<b>Title:</b>	<b>How to Disable Carrousel</b>	<b>ID:</b>	
		0134	
<b>Date in:</b>	<b>Response:</b>	<b>Model:</b>	<b>Author:</b>
2004-11-11	2004-11-11	-	CMa

## SMC Dual Stepper Board SyncBus Mode

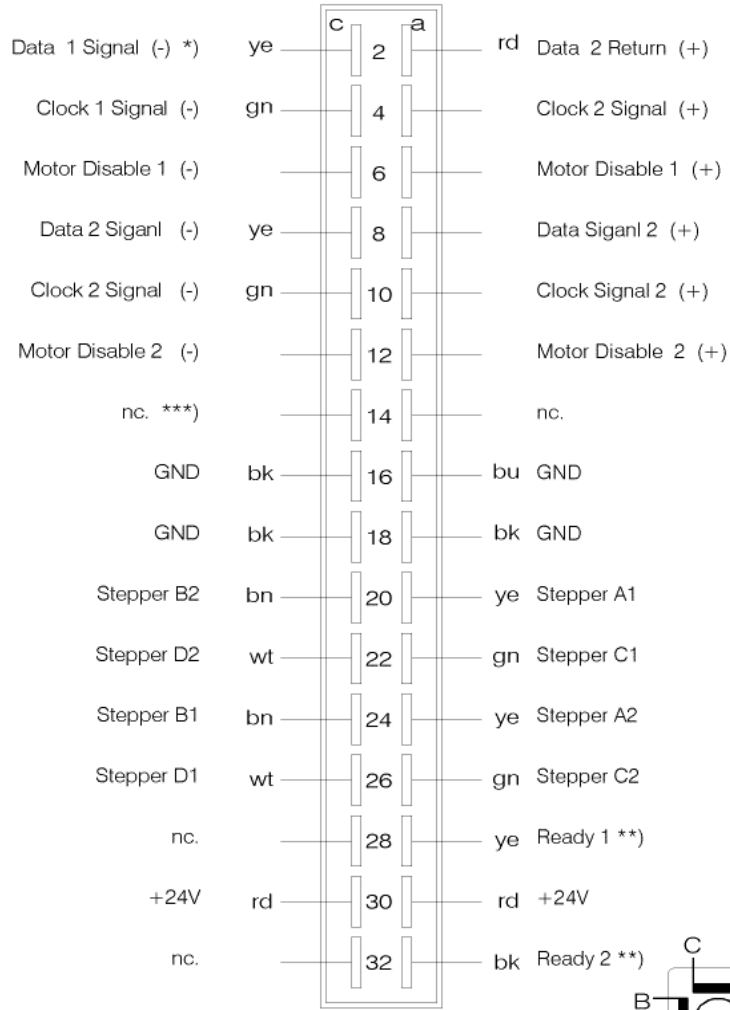
I need a drawing to disable the ambi carousels we have here at Novartis (s/n 8111 & 8112). The information you and Wes provided will not work on these as these carousels are disabled via the stepper card and not the PLC. I am currently on site at the facility and need this info right away. Hope to here from you shortly.

You need to ground 6c to disable the carrousel. The wire needs to be on the second SMC (half equipped) SMC Card.
